# Gaps/inadequacies in Madison Metro's CATEX checklist form

# Gaps/inadequacies in Madison Metro's CATEX checklist form

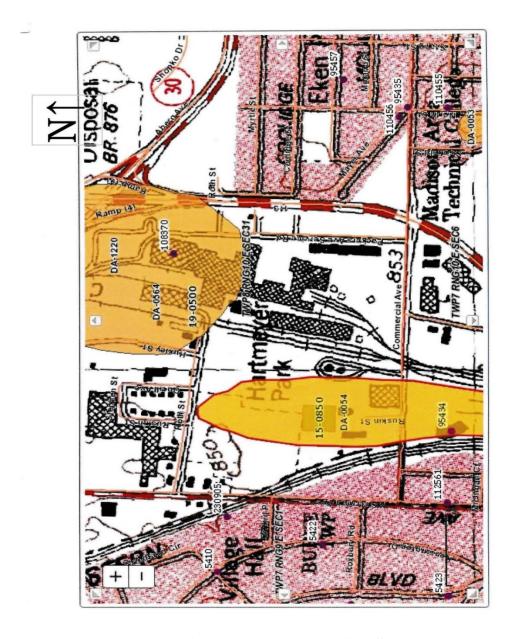
However, not listed in the CATEX document is any mention of **site DA-1220**, which is located on Lot #1, to the north of buildings 50/50A (see below map). This burial site will also need to be assessed by the SHPO when considering this site for any future redevelopment on Lot #1. In a letter from Heather Bailey, a preservation planner with the city of Madison, she stated, that "portions of Lot 1 and 2 are identified as human burial site (DA-0564) and protected under Wis. Stats 157.70. And ground disturbing activities must first secure a Request to Disturb from the Wisconsin Historical Society before a permit is issued." In addition, the FTA has indicated that "any ground disturbing activities within the APE be monitored by a qualified archeologist." Burial site DA-1220 should have been included in the determination as it is located on the site designated for future redevelopment for employment.
